Interagency Aviation TECH BULLETIN

No. IATB 2014-03

SUBJECT: Onboard Systems Bell 206L/407 Manual Release Cable

SERVICE BULLETIN

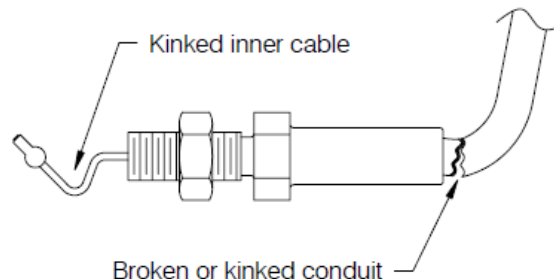
1) *Replace* Manual Release Cable P/N 268-004-00 *or* 268-011-00 with Manual Release Cable P/N 268-004-01. The redesigned Manual Release Cable incorporates more flexible conduit, improved end fittings, and increased length. These improvements extend the service life of the manual release cable.

2) Conduct daily pre-flight checks of the manual release cable and replace it as condition requires. A warning placard, P/N 215-272-00, is affixed to the current version of the 268-004-01 cable. The placard expresses the messages below and draws attention to the cable condition. *Careful cable inspection and timely replacement is essential to continued safe operation.*

Figure 1 Manual Release Cable (200-259-00 kit configuration shown)

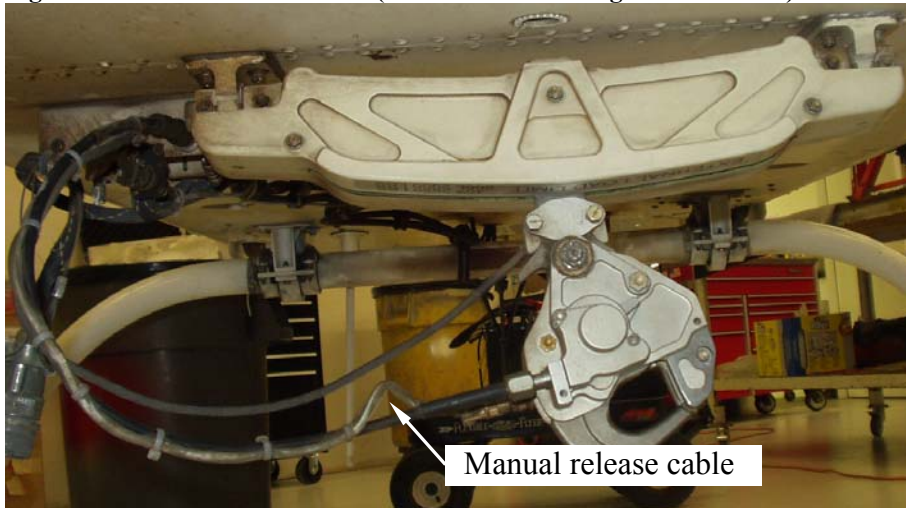
Description: Onboard Systems has had reported cases of failure of the Manual Release Cable P/N 268-004-00. This cable is used to connect the release mechanism of the cargo hook to the fixed manual release cable as part of the backup release system (see Figure 1). Failure of the mechanical release cable can cause an uncommanded release.

Accomplishment Instructions: Replace the existing Manual Release Cable (P/N 268-004-00 or P/N 268-011-00) with the new Manual Release Cable (P/N 268-004-01) per the following instructions. The new cable can be identified by the part number marking on the cable housing.

Figure 4 Manual Release Cable Installation (528-023-01 cargo hook shown)

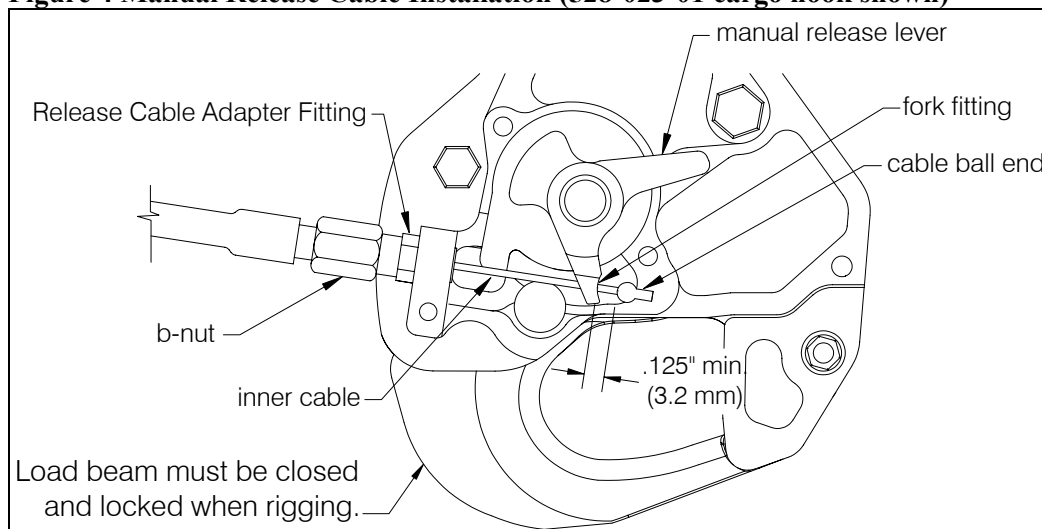
- At the cargo hook insert the inner cable through the release cable adapter fitting and the fork fitting (see Figure 4)
- Thread the manual release cable's b-nut onto the release cable adapter fitting and tighten securely.
- Verify the Manual Release Cable is rigged correctly by rotating the manual release lever in the clockwise direction to remove free play (this is felt as the lever rotates relatively easily for

several degrees before free play is taken up) and measure the gap between the cable ball end and the fork fitting as shown in Figure 4. This gap should be a minimum of .125 inches (3.2 mm).

Failure to appropriately rig the manual release cable free play will result in uncommanded release of load.

Adjustment of the manual release cable free play must be accomplished with the cargo hook in the closed and locked position.
